DRAWN	R. STOKES	CLASSIFICATION	STANDARD
CHECKED	<i>[Signature]</i>	HOLE PLUG	CSP 423
STRESSED	<i>[Signature]</i>		
APPROVED	<i>[Signature]</i>

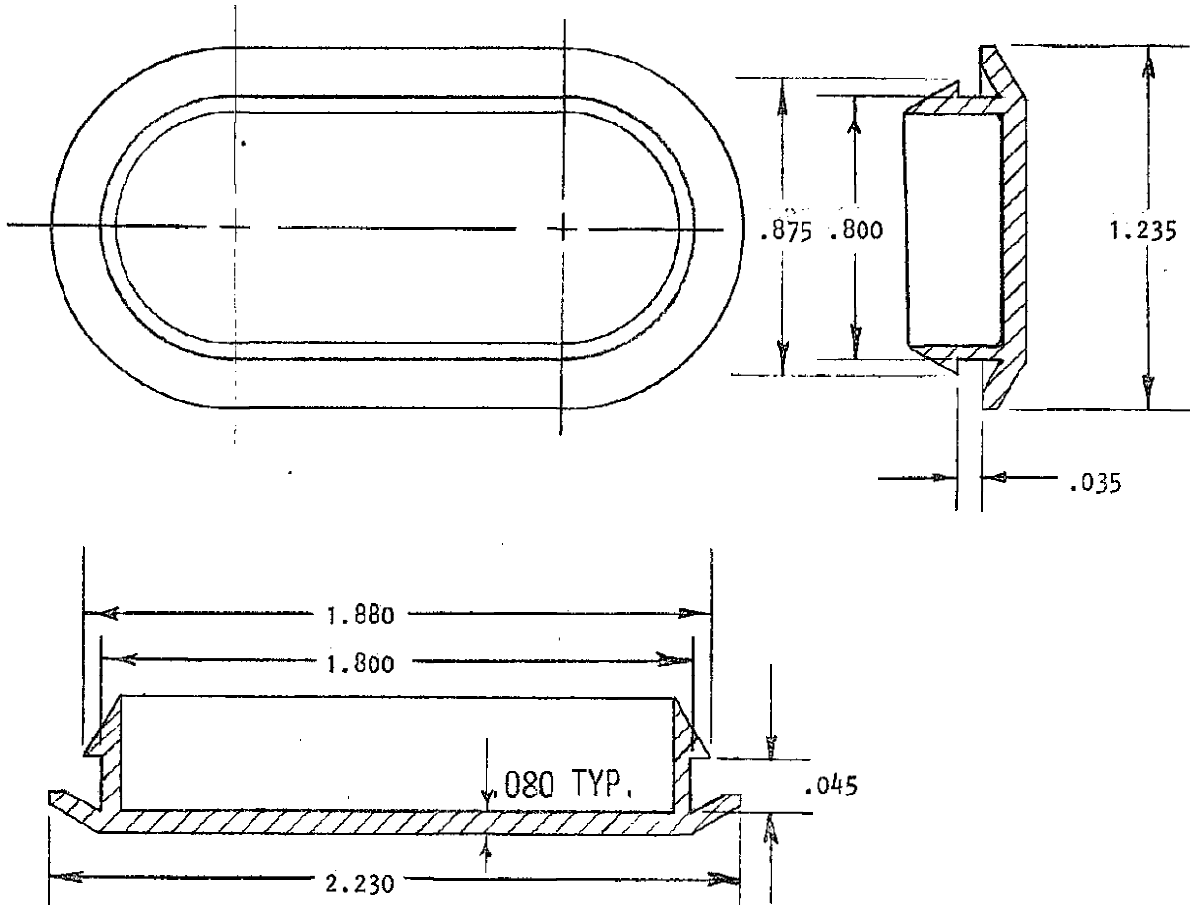
1. ~~DIMENSION 'A' MUST PROVIDE SNUG FIT IN HOLES IN SHEET METAL THICKNESS .040.~~
2. MATERIAL: LOW DENSITY POLYETHYLENE - BLACK
3. PLUG TO FIT HOLE 1.800 X .800
4. DIMENSIONS IN INCHES, TOLERANCES $\pm .005$.
5. IDENTIFY AS CSP 423-1.
6. AVAILABLE FROM CENTENNIAL PLASTICS, MISSISSAUGA

A DIMS CHANGED. 1.235 WAS 1.240, .800 WAS .810, .875 WAS .890, 1.880 WAS 1.890, 1.800 WAS 1.810, 2.230 WAS 2.240, .045 WAS .A, DIM. ADD'D .035, NOTE 2 WAS - MATERIAL: POLYETHYLENE-BLACK
NOTE 1 DELETED 9-12-86 RS
